County of Los Alamos

Staff Report

Requests for Site Plan and Waivers approval for the construction of a research & development building totaling 83,798 SF to be located at 4200 W Jemez, Los Alamos Research Park.

Public Hearing Date: January 22, 2020
Subject: Case No. SIT-2019-0037, WVR-2019-0086, WVR-2019-0087
Owners/Applicants: Patrick Sullivan, Property Owner/Donna Marion, Applicant
Case Manager: Ryan Foster, AICP, Principal Planner

C-201

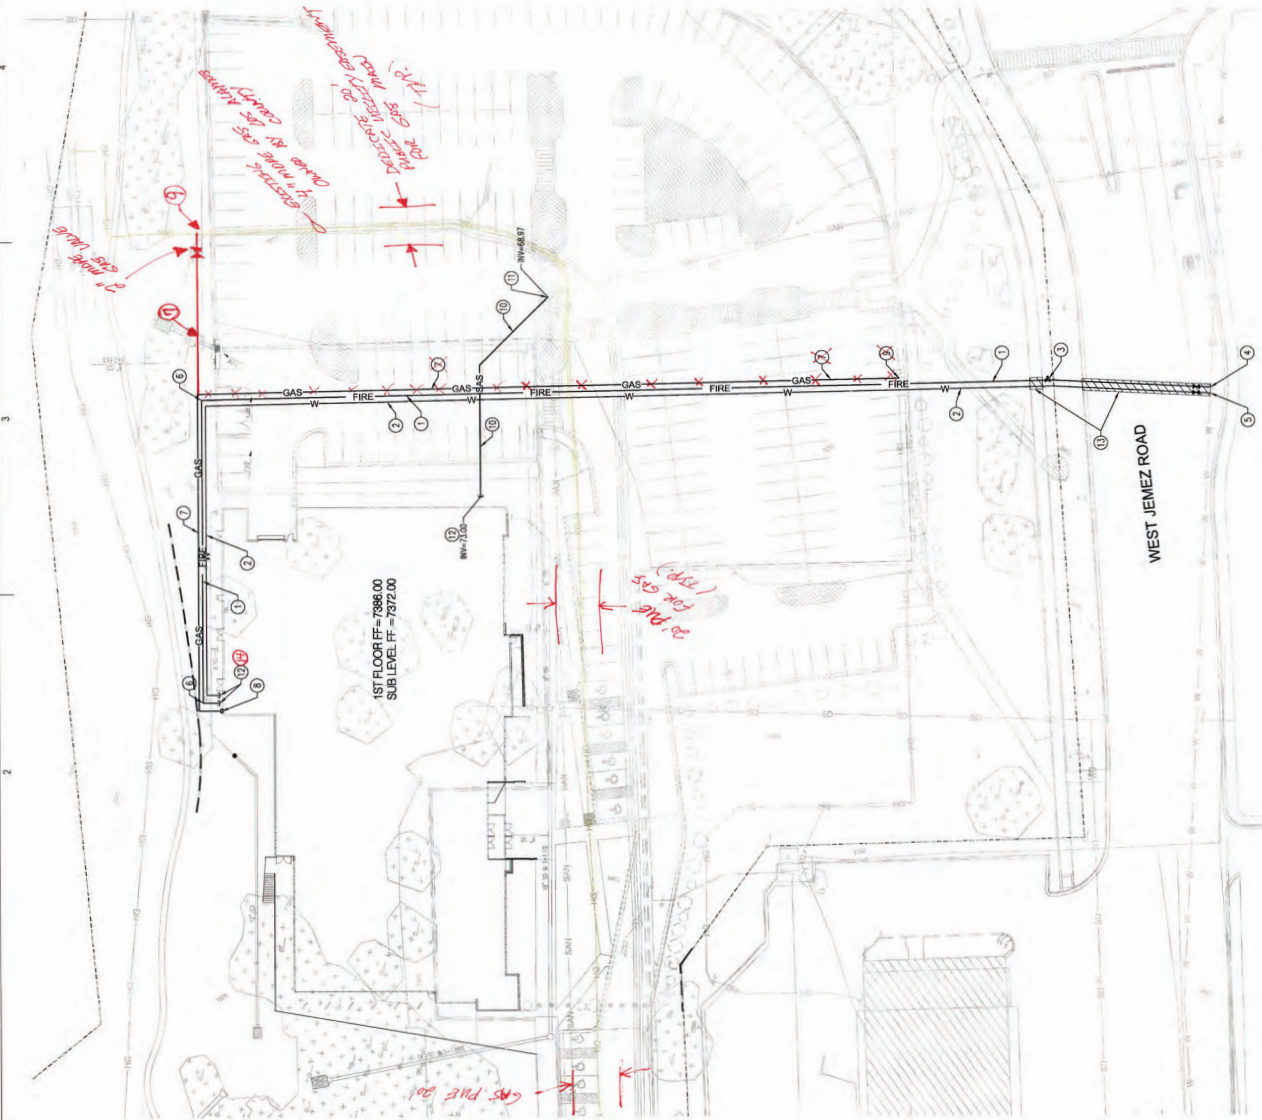
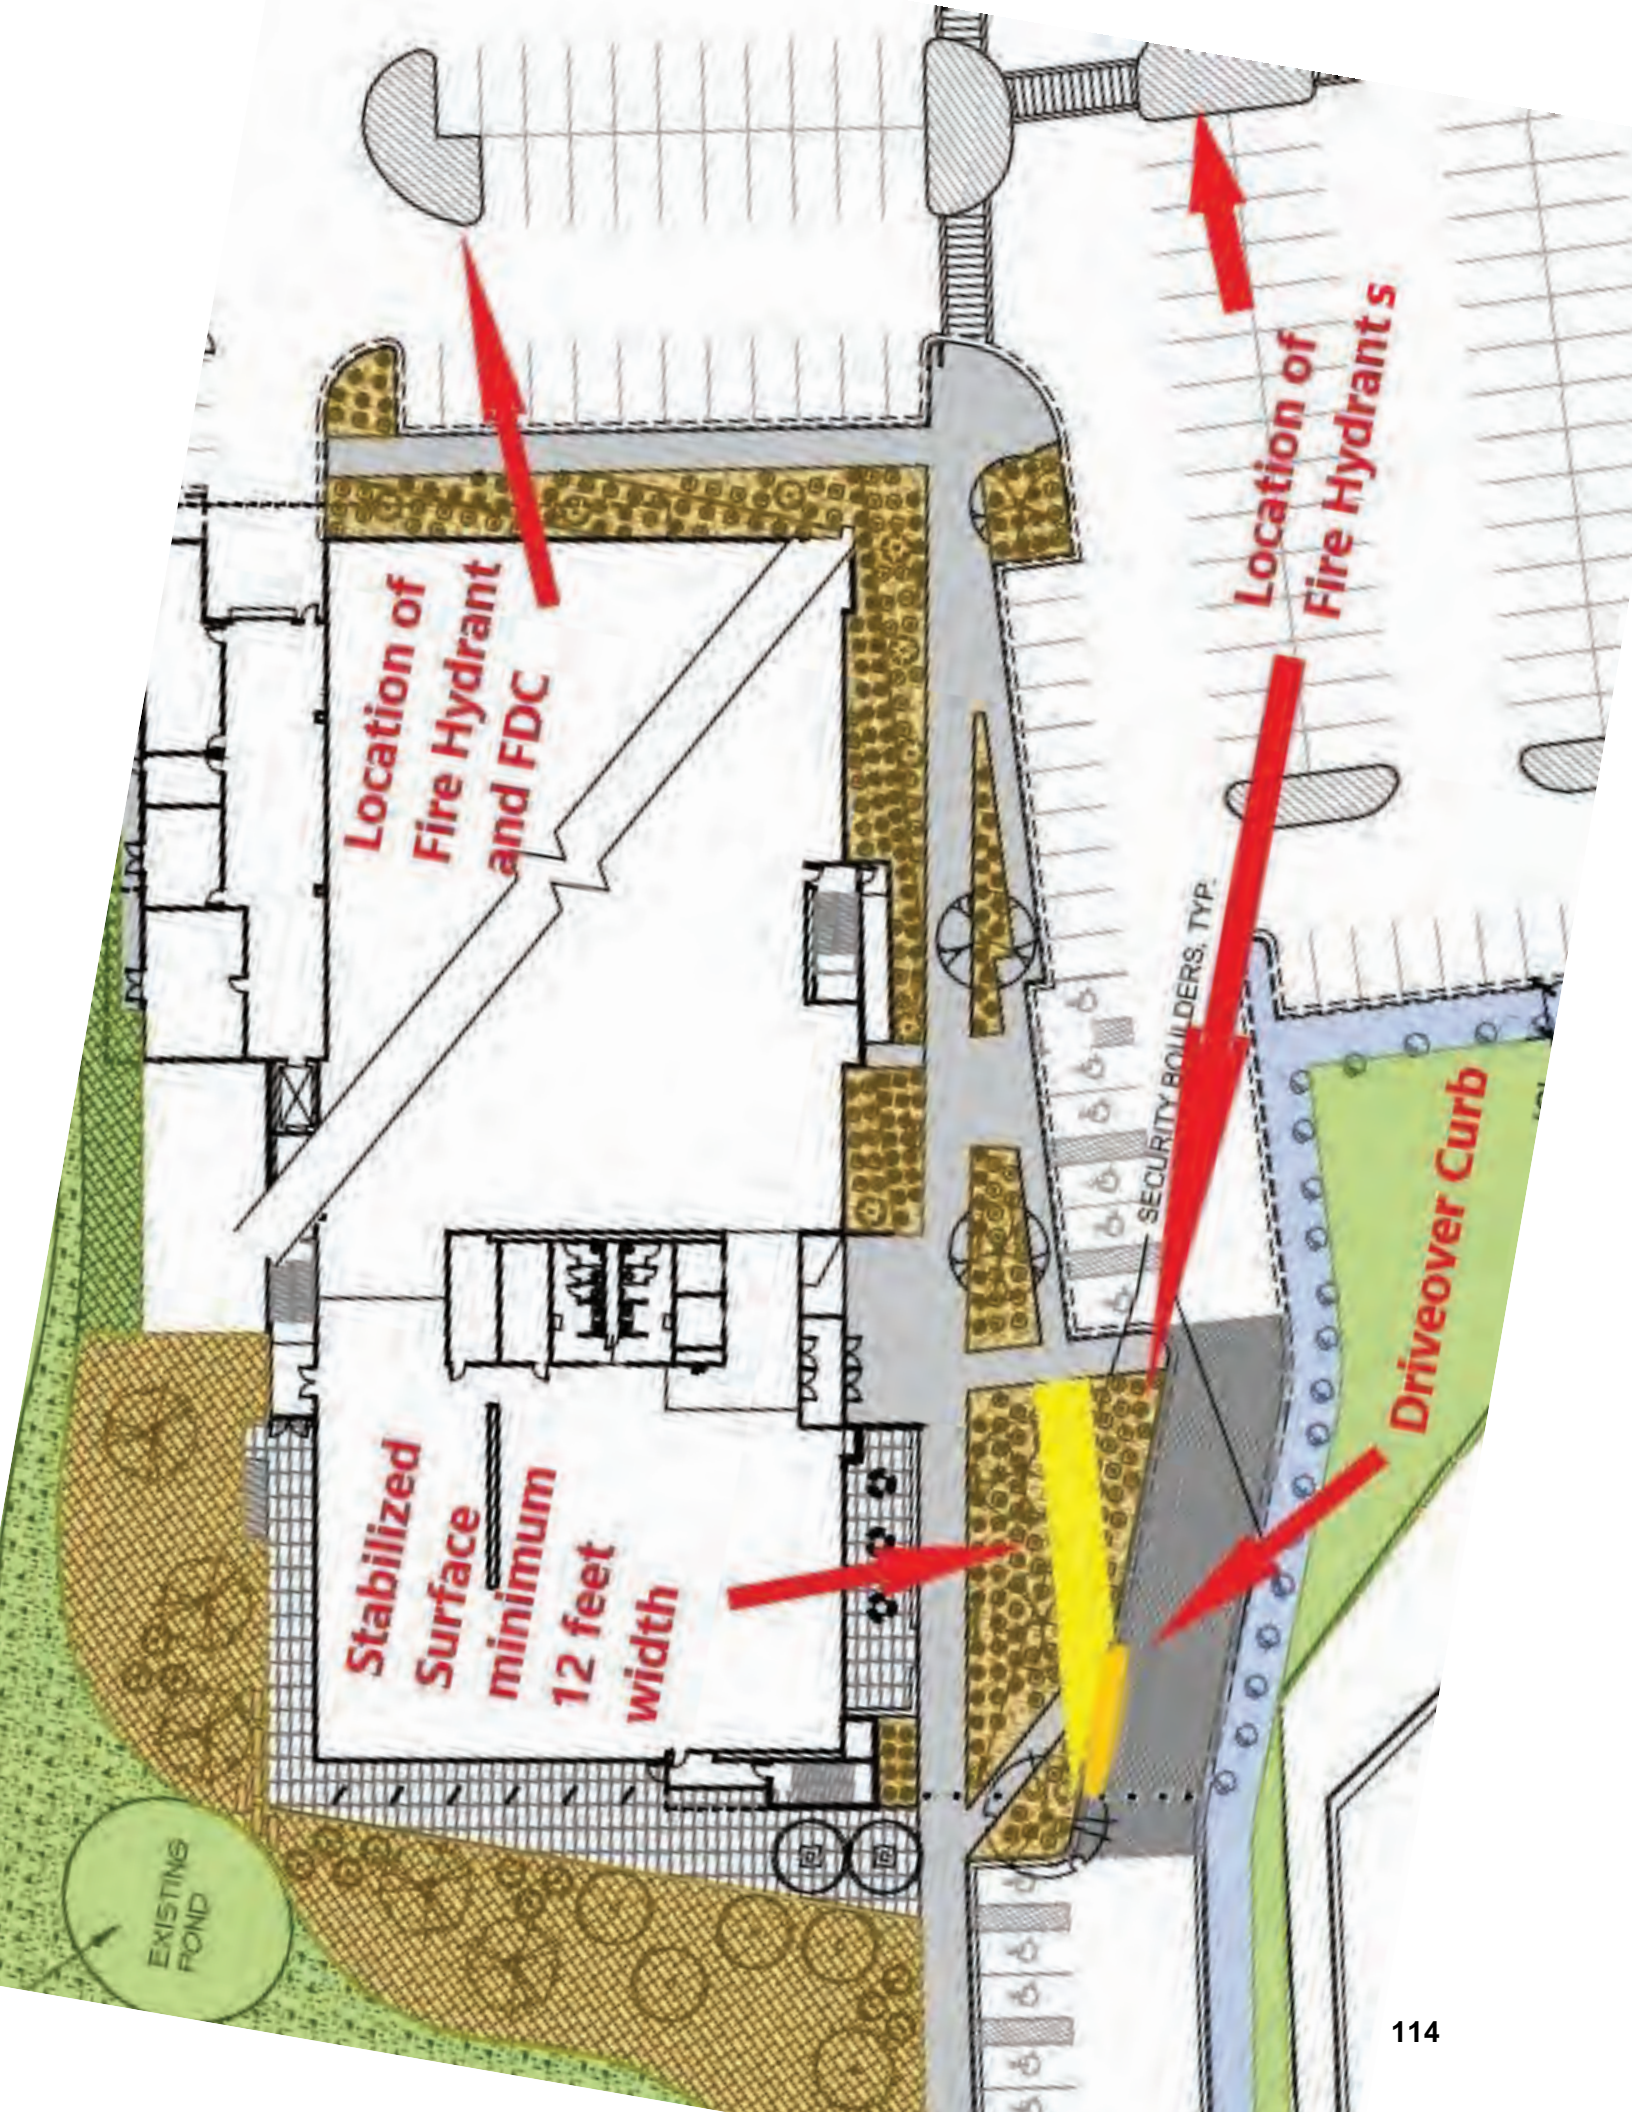
- b. An Easement Plan dedicating easements for new and existing utilities shall be filed prior to occupying the building.
 - c. See the attached sheets for additional DPU comments.

1. Per Department of Utilities:
 - a. Applicant shall submit final utility plans, stamped by a New Mexico professional engineer, with the application for building permit.
